Applicant respectfully requests reconsideration and withdrawal of the rejections of the claims and objections to the application, in view of the foregoing amendments and following remarks.

AMENDMENTS TO THE DRAWINGS

The attached sheets of drawings includes changes to Figures 2, 4, 6, 7, and 11. These sheets replace the original sheets for Figure 2, 4, 6, 7, and 11.

FIG. 2

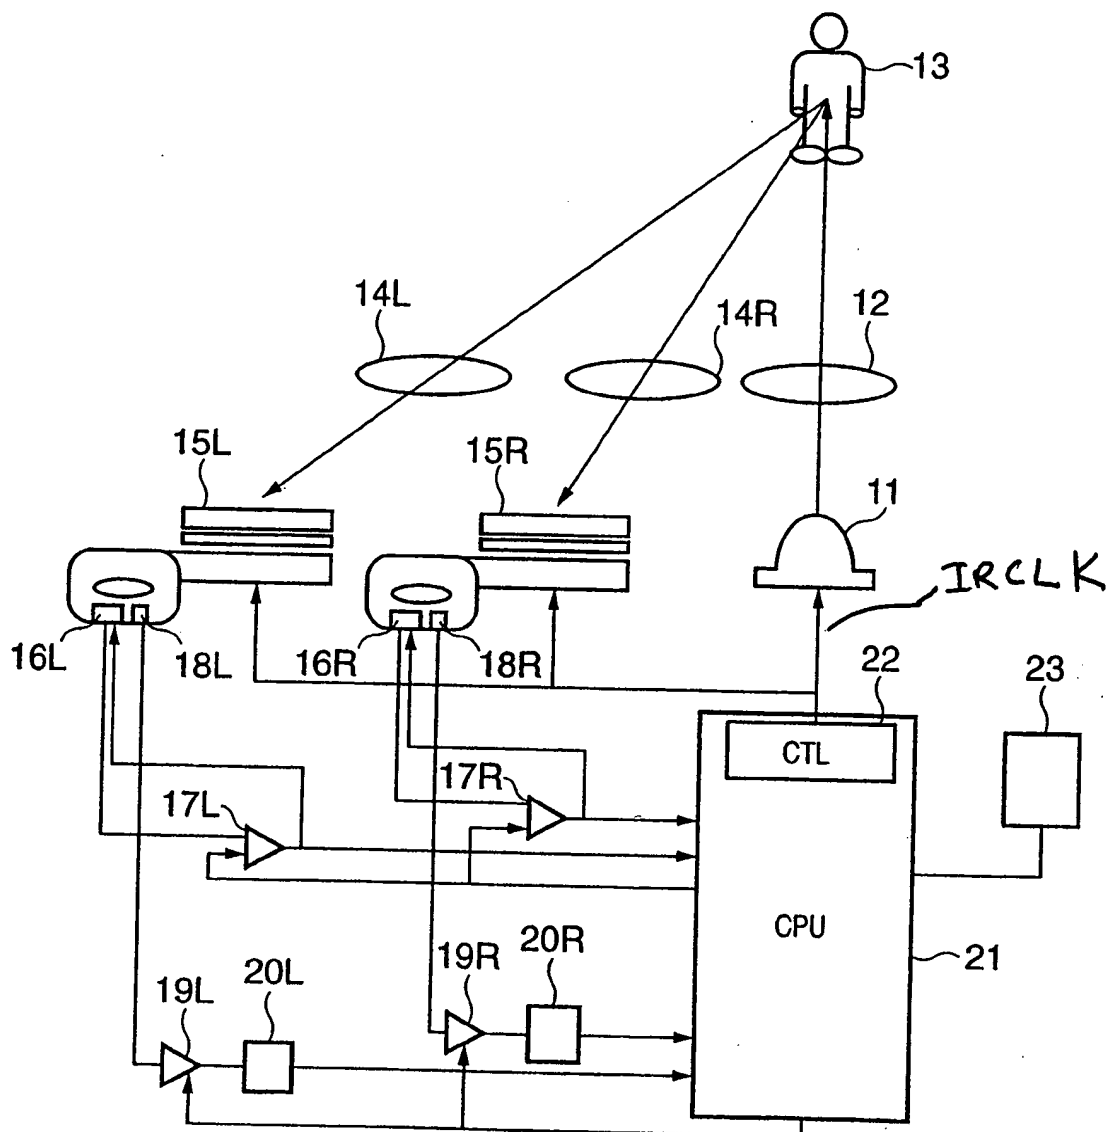
The Office Action objects to the drawings of the application, stating that they fail to comply with 37 C.F.R. §1.84(p)(5) because (1) the drawings do not include the reference sign “IRCLK” mentioned in the description; and (2) the drawings include the following reference character(s) not mentioned in the description: ST1, ST2, SH, CCDCLR, 49, 17, 18, and 19.¹ (3) there are references to 19L, 19R, 18L, 18R, 17L, and 17R, but there is no generic description of 17-19 (4) Figure 11 should be designated with the legend “Prior Art” because only that which is old is illustrated.

In response, Applicant has amended Figure 2 to show the reference sign “IRCLK”. Applicant has also amended Figure 4 to remove the reference to “ST1, ST2, SH, CCDCLR, 49, 17, 18, and 19.”

In the case of Figure 2, the reference sign “IRCLK” has been added. The reference sign “IRCLK” refers to the vertical arrow that connects reference numeral 22 with 11 in Figure 2.

FIG. 4

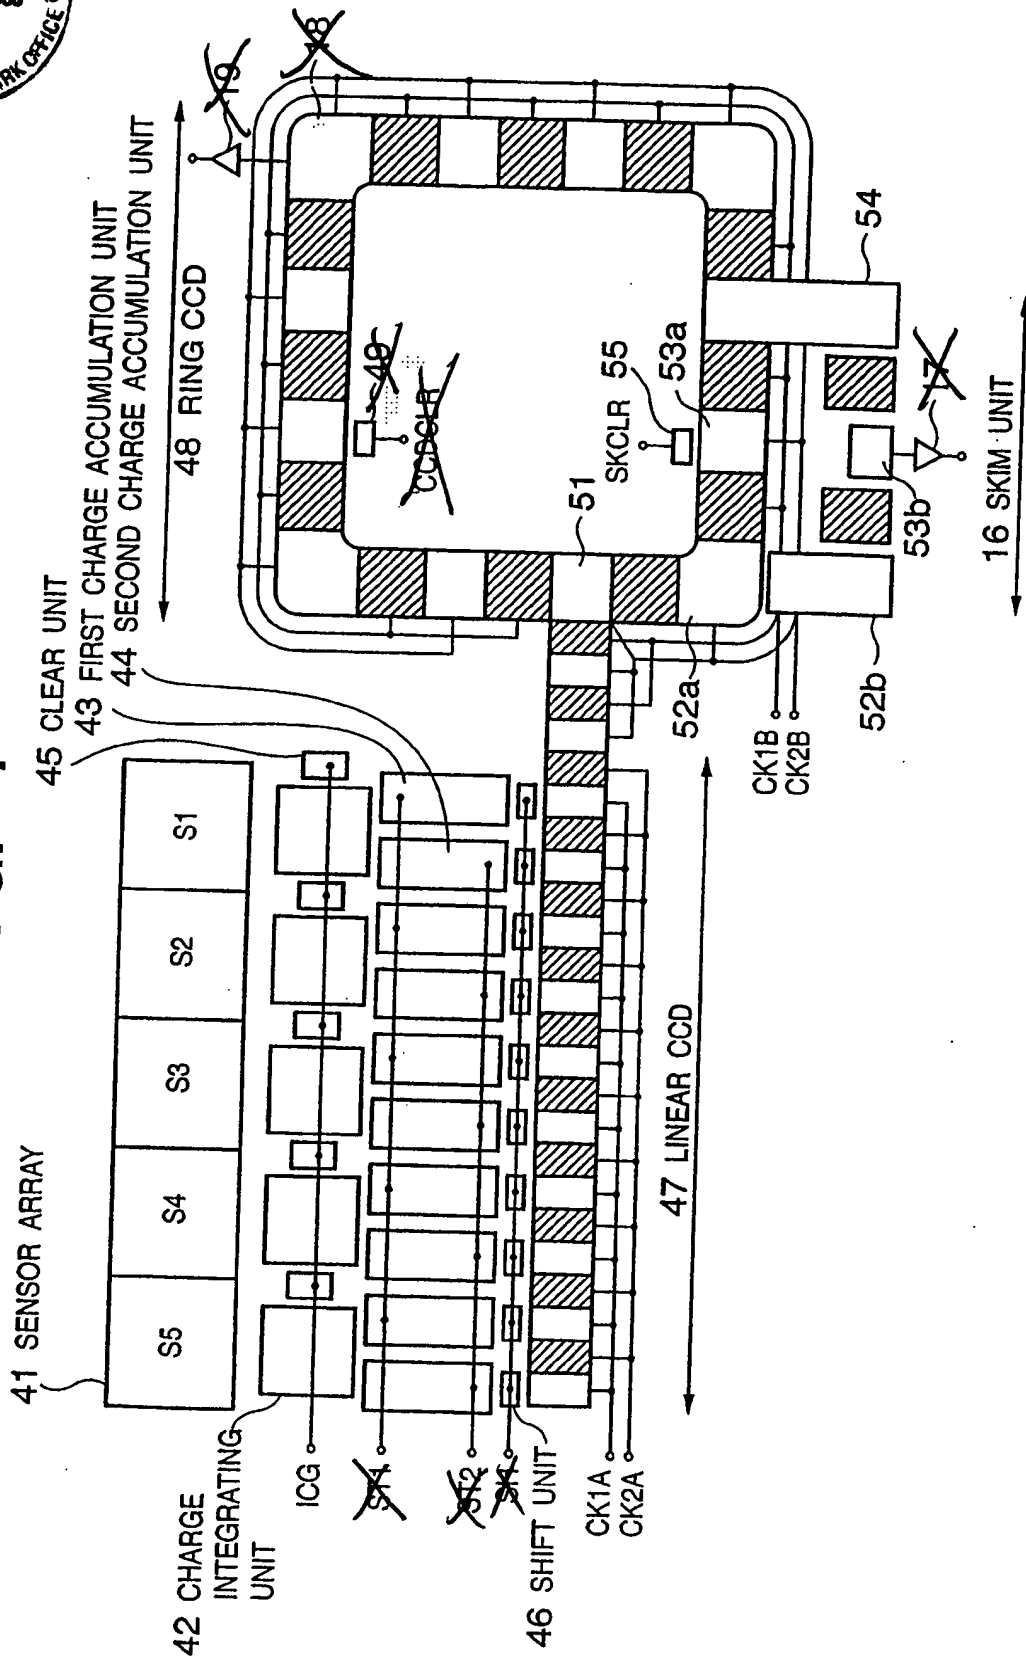
¹ Applicant notes that the Office Action alleges that the terms “ST1, ST2, SH, CCDCLR, 49, 17, 18, and 19” are not found in Figure 14. Applicant, however, notes that there are only 11 figures in this application. It is Applicant’s understanding that the objection was to Figure 4, not 14. Applicant respectfully requests Examiner to inform Applicant if Applicant’s understanding is not correct.

In Figure 4, the reference signs “ST1”, “ST2”, “SH”, “CCDCLR”, “49”, “17”, “18”, and “19” have been deleted.

FIG. 6

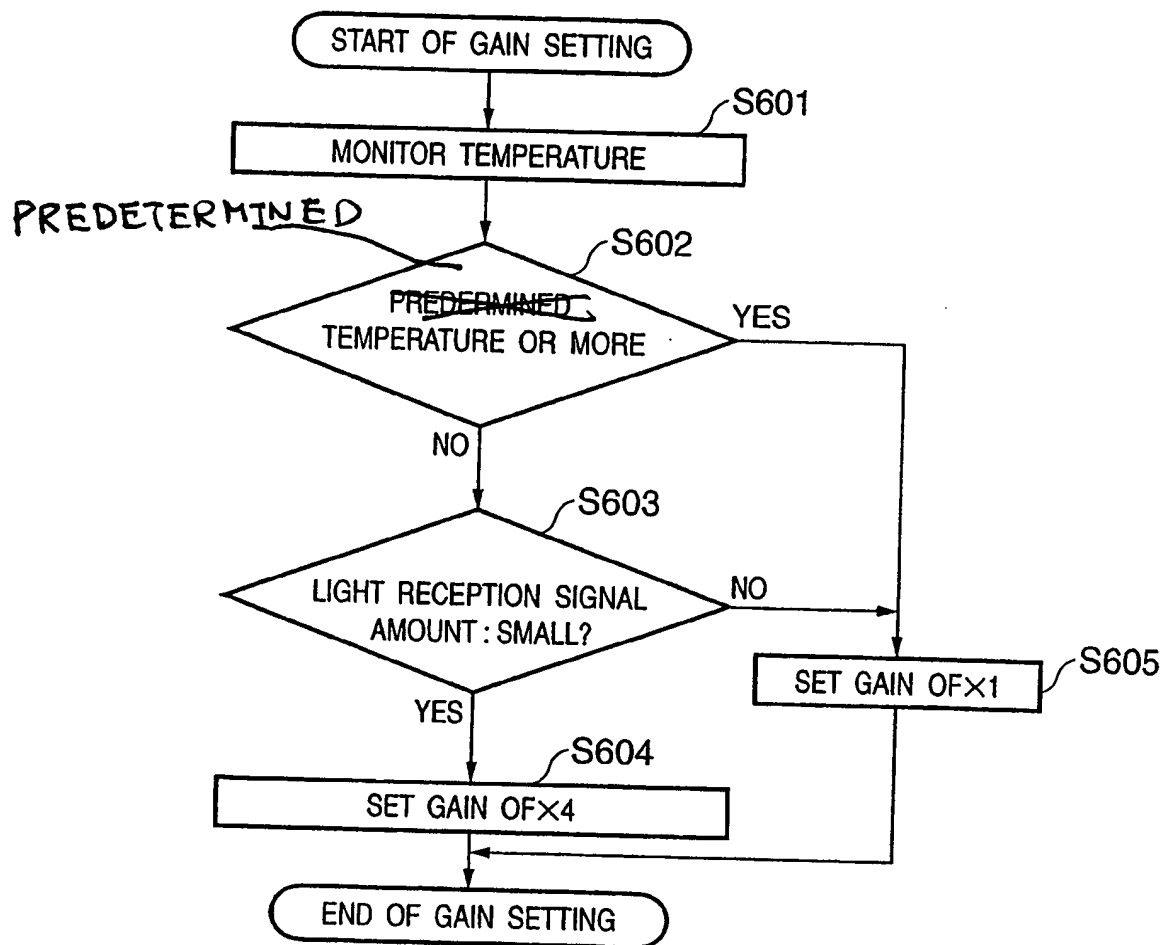
Additionally, Applicant has amended Figures 6 and 7 to correct minor typographical errors. In Figure 6, step S602 has been amended to read “PREDETERMINED TEMPERATURE OR MORE”, while in Figure 7, step S701 has been amended to read “SET DIFFERENCE OUTPUT”.

In Figure 6, step S602 has been amended to read “PREDETERMINED TEMPERATURE OR MORE”.
